**BOULDER CITY/U.S. 93 CORRIDOR STUDY
“BOULDER CITY BYPASS”**

REEVALUATION

**FINAL ENVIRONMENTAL IMPACT STATEMENT
BOULDER CITY/U.S. 93 CORRIDOR STUDY
AND
SECTION 4(F) EVALUATION**

**FHWA-NV-EIS-00-02-F
CLARK COUNTY, NEVADA
August 2009**

Figure 2. Right-of-way Acquisitions, Boulder City/ US 93 Corridor Study FEIS April 2005

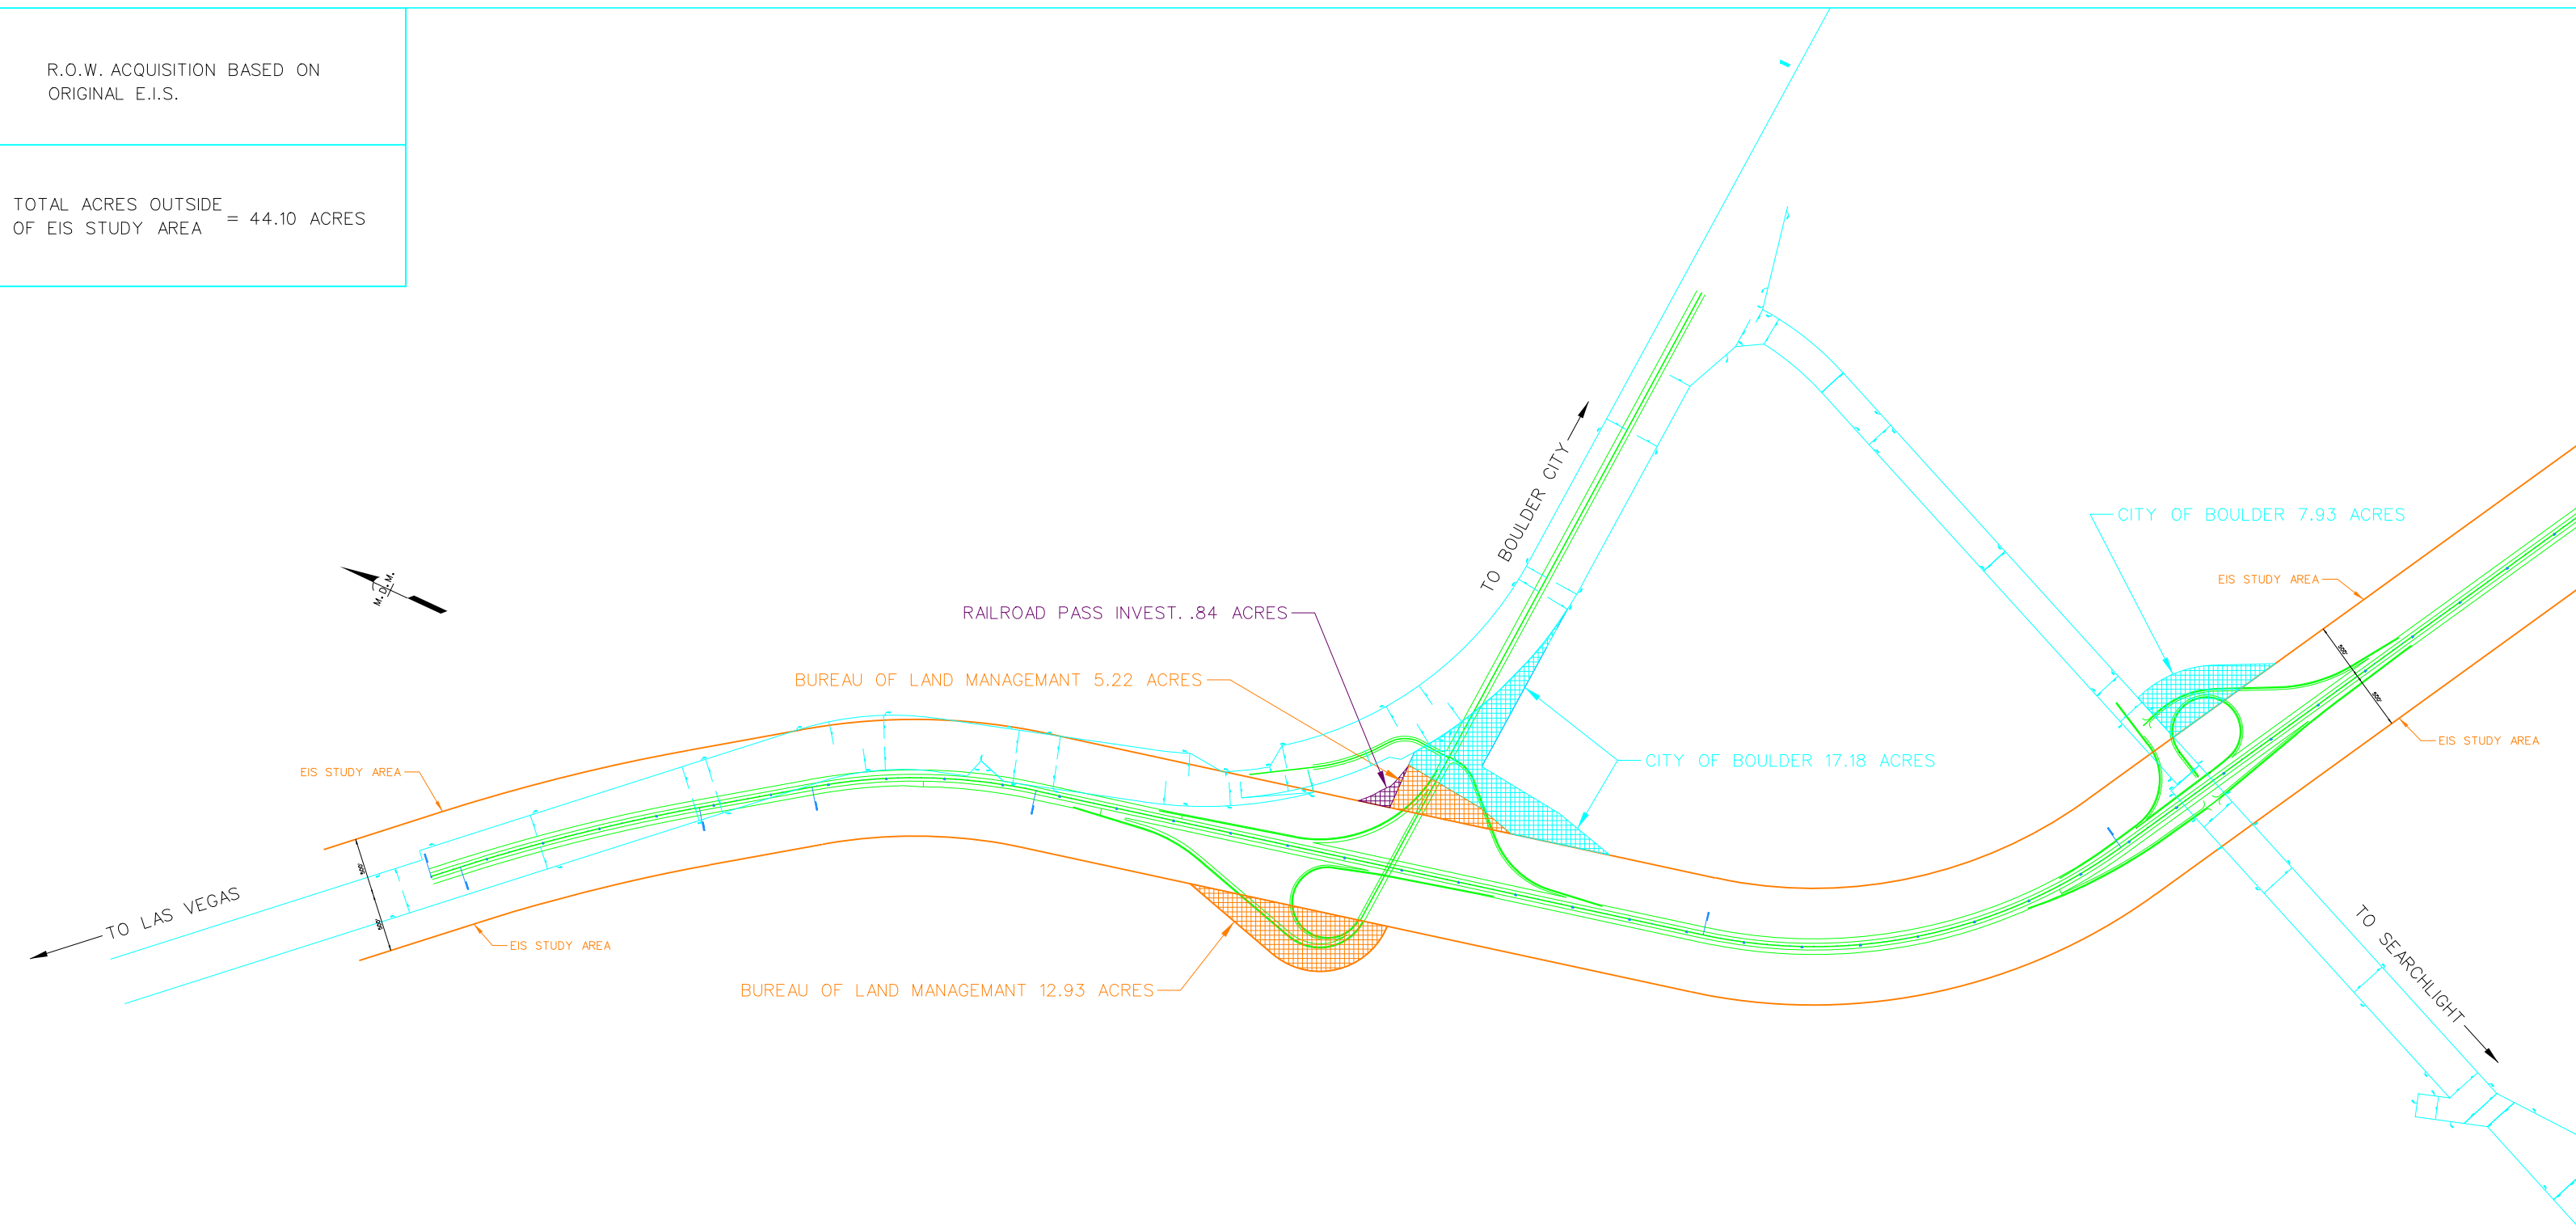
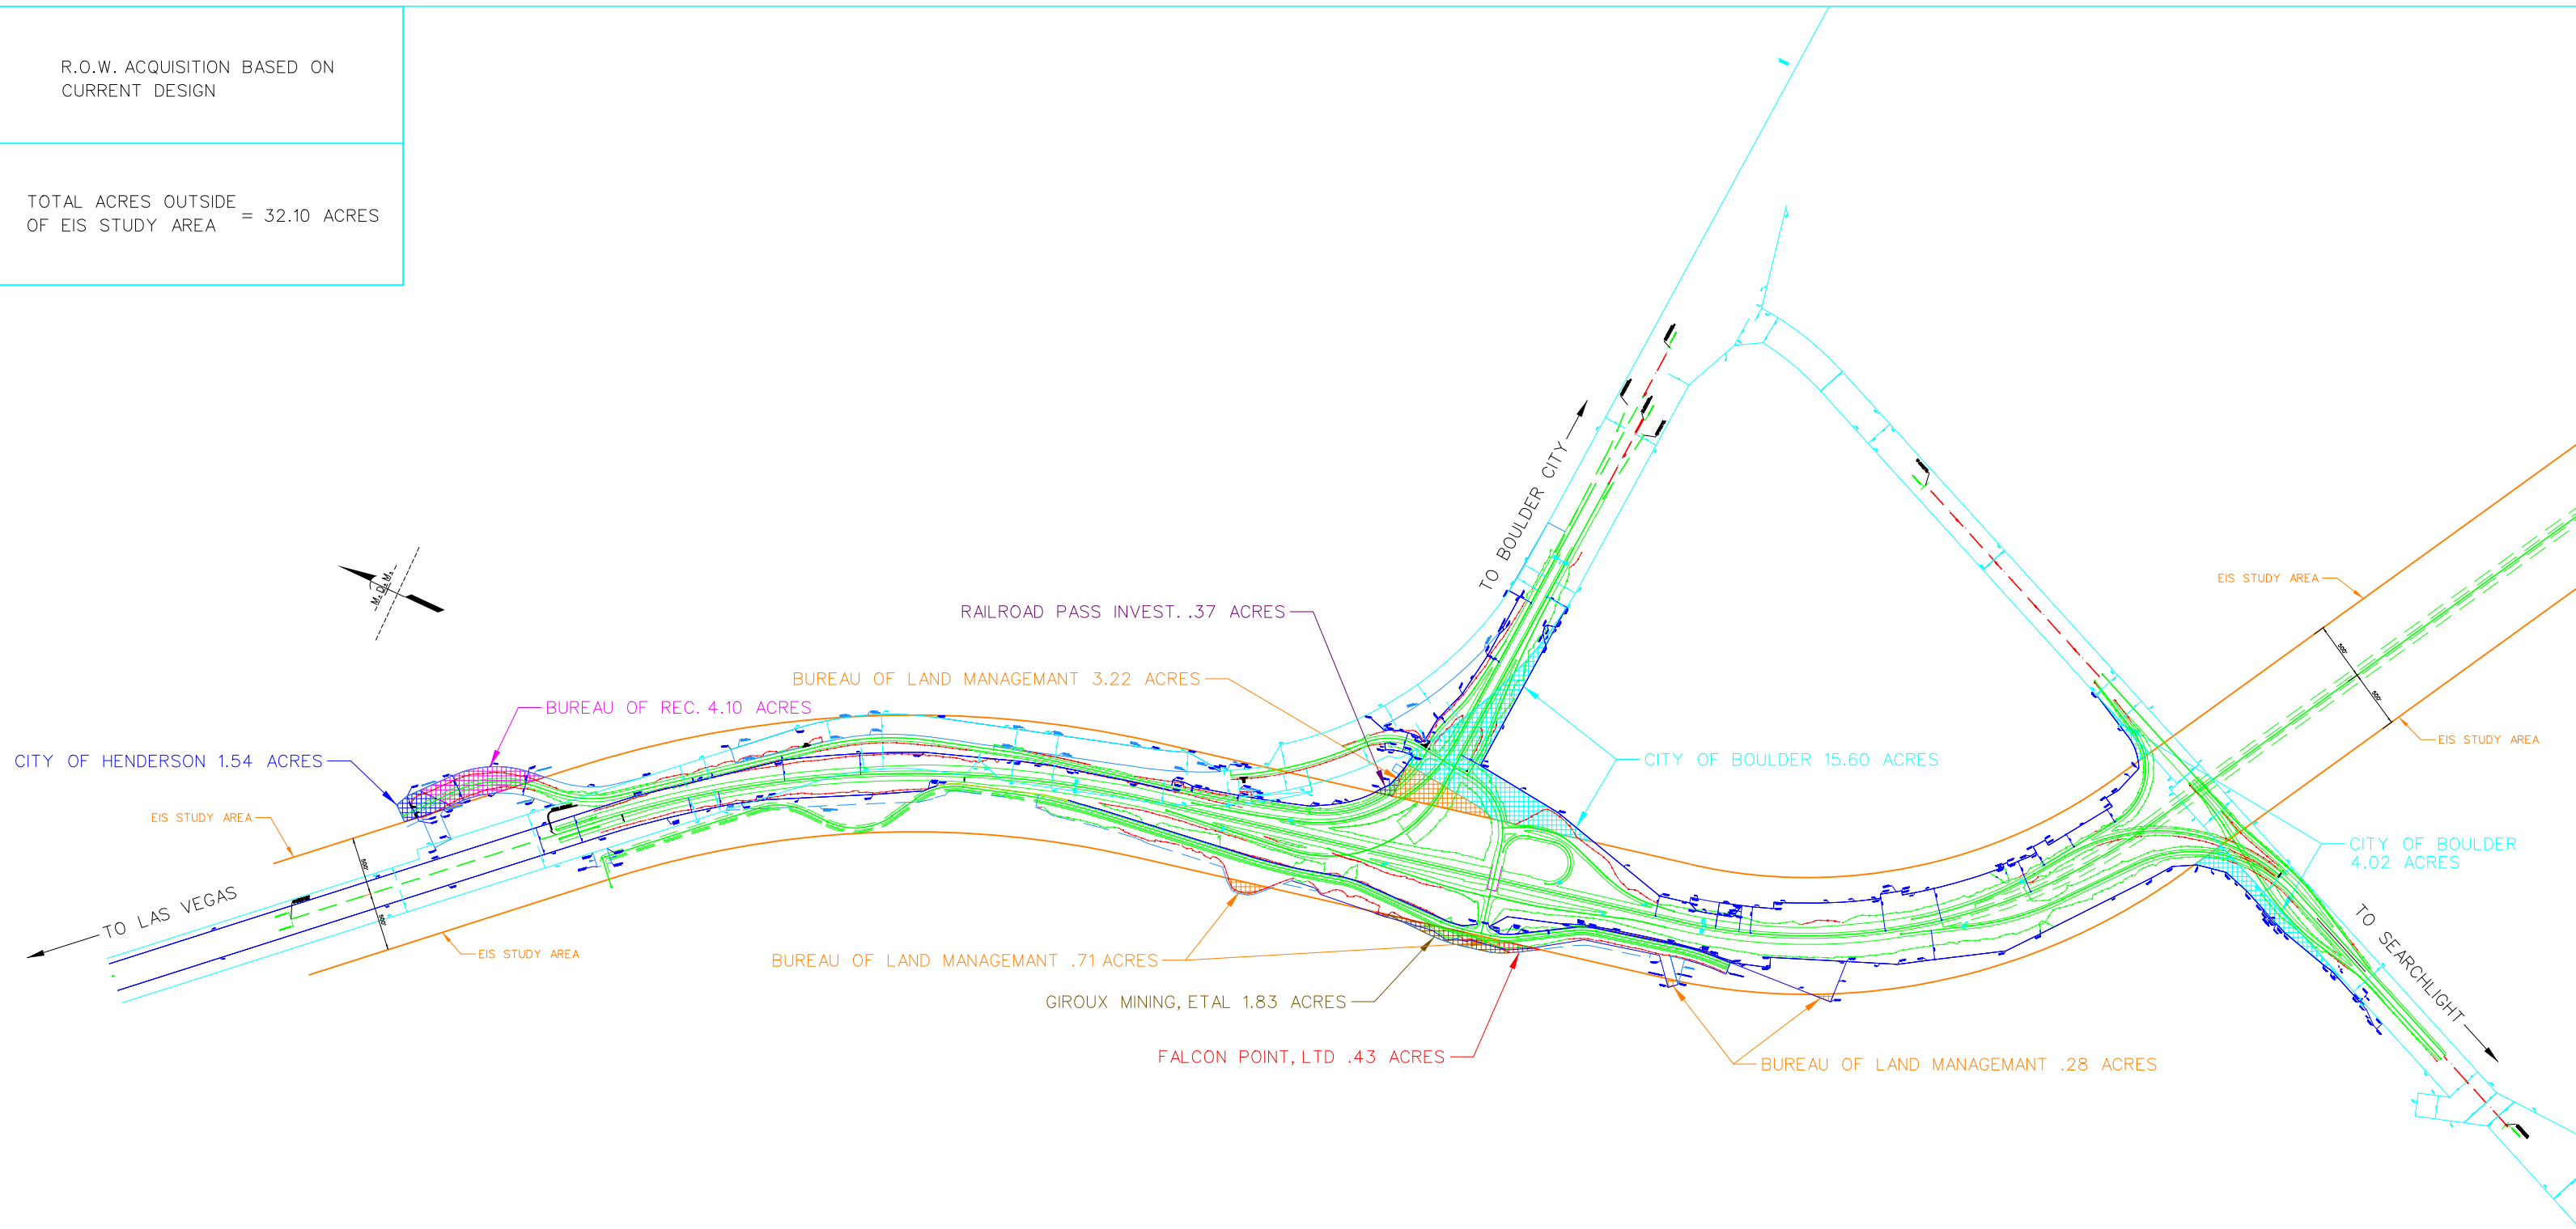
The following is a description of the design modifications made as the project has moved to final design for Phase 1 of the project. Please refer to Figures 2 and 3 to note the changes between the design alternative as proposed in the EIS compared to the current design modifications. The changes have been in terms of reducing the overall footprint of the project, lessening impacts to the adjacent area, and improving the operations and safety of the roadway as noted in the figures and the description below.

As depicted in Figures 2 & 3, the Phase 1 design refinements have reduced overall right-of-way impacts from 44.1 acres (see Figure 2) of right-of-way acquisitions based on the original FEIS to 32.1 acres (see Figure 3) of right-of-way acquisitions based on the current design. However, one commercial property, Goodfellow Corp., 12451 Old Hwy 95, Boulder City, Nevada (near the quarry pit) will be affected by the current Phase 1 alignment which will require relocating buildings on the property. At least one building may need to be acquired and demolished rather than relocated. The impacts to the commercial property will be mitigated according to the Uniform Relocation Assistance and Real Property Acquisition Policies Act of 1970, amended in 1987 (the Uniform Act).
